FJ CRUISER

OUTLINE OF NEW FEATURES

The following changes have been made to the 2012 model year.

1. Exterior

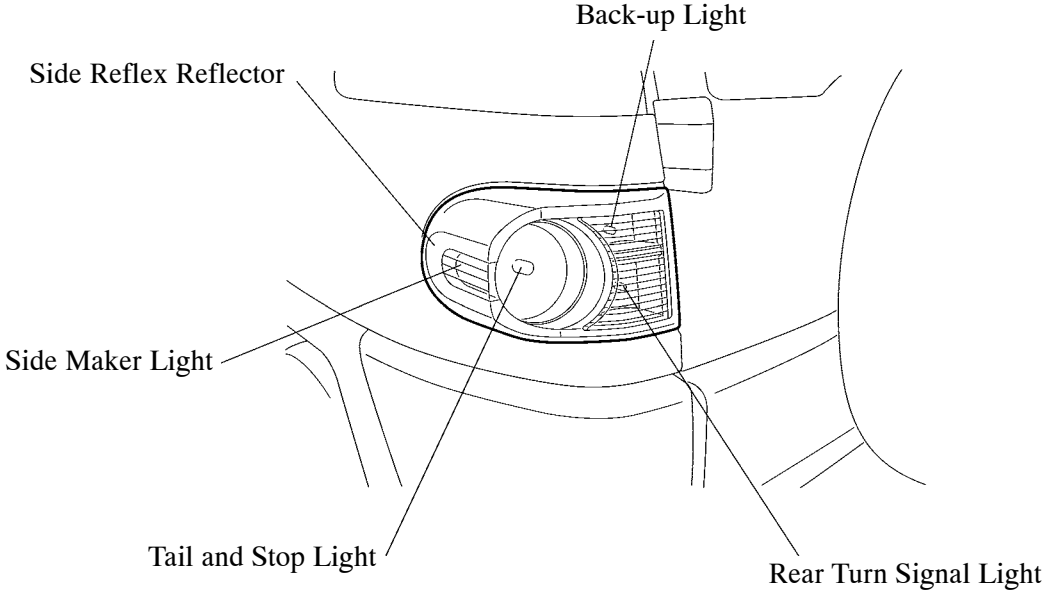
The design of the rear combination light has been changed.

▶ Multiplex Network Master Switch Assembly ◀

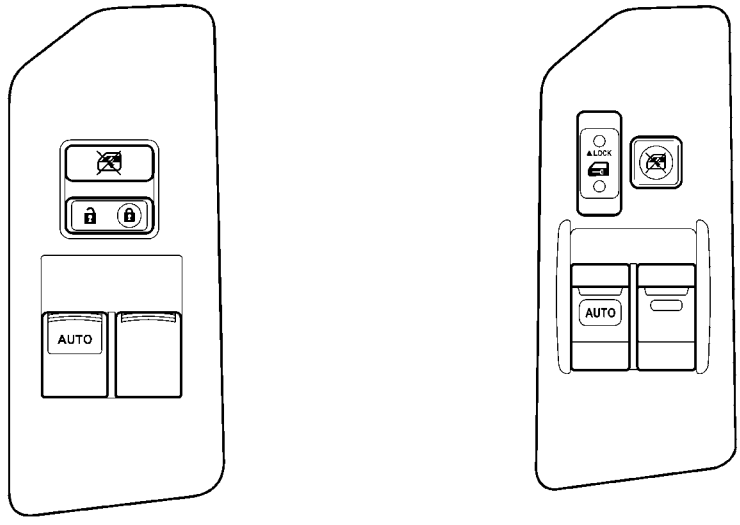
The design of the multiplex network master switch assembly and power window regulator switch assembly has been changed.
